UNITED STATES
NUCLEAR REGULATORY COMMISSION
WASHINGTON, D. C. 20555

LICENSEE: Tennessee Valley Authority

FACILITY: Browns Ferry Nuclear Plant, Units 1, 2, and 3

SUBJECT: SUMMARY OF THE DECEMBER 16, 1992 MEETING REGARDING DESIGN AND
OPERATION OF THE BROWNS FERRY HARDENED WETWELL VENT

VENT PATH

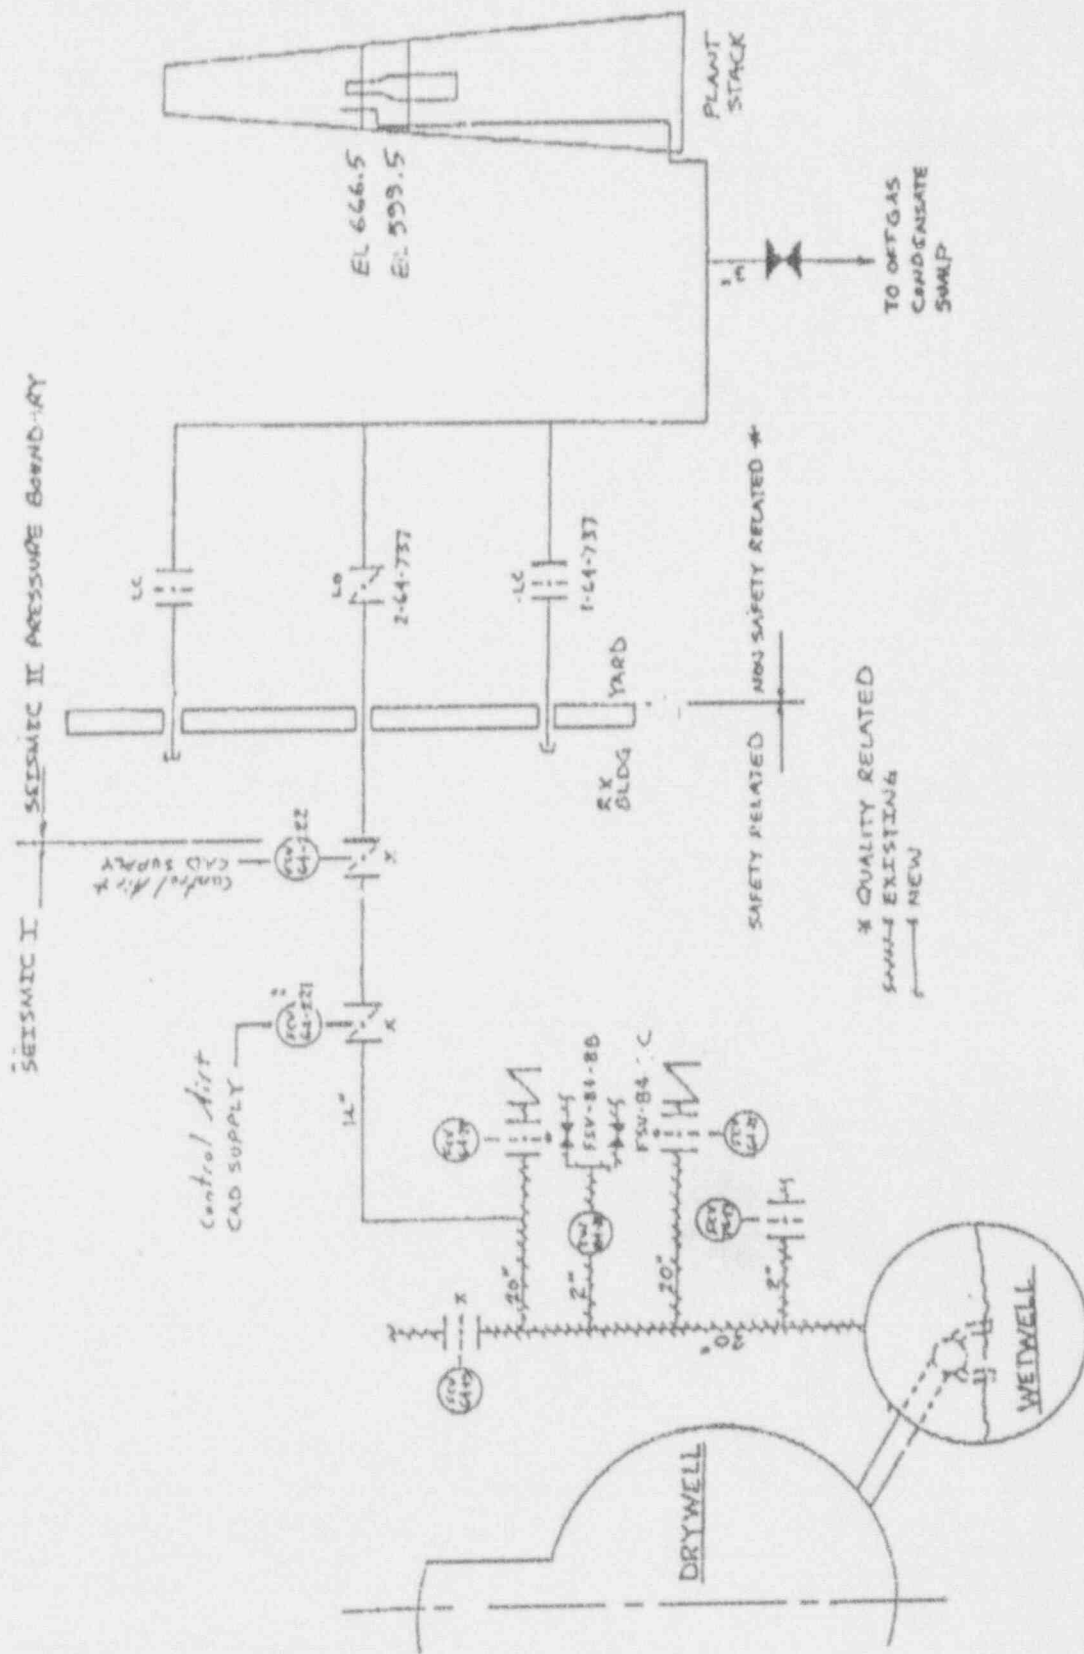
This meeting was held to follow up on a finding from a team inspection conducted at BFN which examined engineering design change packages. This finding noted that the hardened wetwell vent design included three drain valves which required local manual action when the vent is operated. The inspection team was concerned these local actions may be prevented by high radiation fields in the event of core damage, and, therefore, plant operators would be unable to perform actions called for in the Browns Ferry emergency operating procedures.

TOPIC	SPOKESMAN
ISSUES	<ul style="list-style-type: none">• CURRENT DESIGN REQUIRES MANUAL OPENING OF A DRAIN VALVE IN THE STACK PRIOR TO INITIATION OF VENTING• CURRENT DESIGN REQUIRES MANUAL CYCLING OF LOW POINT DRAIN VALVES PRIOR TO RE-USING THE VENT• EMERGENCY OPERATING INSTRUCTIONS ARE SYMPTOMATIC AND REQUIRE VENTING AT ELEVATED CONTAINMENT PRESSURES TO PRECLUDE CONTAINMENT FAILURE REGARDLESS OF RADIOLOGICAL CONDITIONS	J. E. MCCARTHY

In response to the concern raised by the team inspection, TVA stated that they will install float valves on two of the three drain lines. These float valves will operate passively, eliminating the need for local operator action on these lines. The third drain valve is located within the plant stack. TVA is evaluating whether or not this valve can be opened during an accident and left

open without increasing ground-level radiation source terms and associated doses beyond regulatory limits for design basis events. If this valve can be left open, the team's concern regarding local operator action will be resolved. TVA will inform the staff of the results of its evaluation.

TOPIC	SPOKESMAN
CURRENT ACTIVITIES	J. E. MCCARTHY
<ul style="list-style-type: none">• CALCULATIONS BEING PERFORMED TO DETERMINE IF STACK DRAIN VALVE CAN BE LEFT OPEN FOR DESIGN BASIS ACCIDENTS (GROUND LEVEL RELEASE)• STACK DRAIN VALVE ISSUE MUST BE RESOLVED CONCURRENT WITH NRC REVIEW OF CONTROL ROOM EMERGENCY VENTILATION SYSTEM'S CONFORMANCE TO GDC 19• LOW POINT DRAINS VALVES TO BE REPLACED WITH FLOAT VALVES TO PRECLUDE MANUAL OPERATOR ACTION
